Product Change Notification

Date Issued :	January 12, 2026	PCN Number :	517735
Reason for Change :	Packaging Method/Quantity Changing		
Description of Change :	This notification is to inform you about part(s) listed will undergo changes for packaging specification change. No changes will be made to product as part of this change.		
Assessment of Change :	Drop Test		
Planned Implementation Date :	July 12, 2026		
Customer Sample Availability Date:	January 12, 2026		
Last date to request Samples by Customer : April 30, 2026			
Please note if Samples are not requested as per Customer Samples Request date, it may take additional 4-6 weeks to arrange Samples.

■ Show new T&R drawing(170432-9020):

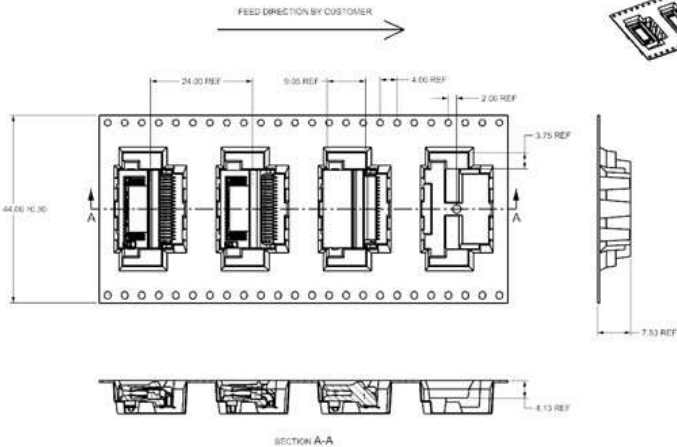
- Four emboss tape have been merged into one emboss tape, and all functions have been merged
- Factors affecting customer experience: It will not affect the customer's current .
Keep same :Tape Width(44mm), Pitch(24mm), Height(7.83mm), Loading quantity(340pc/reel), and suction (grap) position and Pull direction have not been updated.
- Part Number Impact: see below.
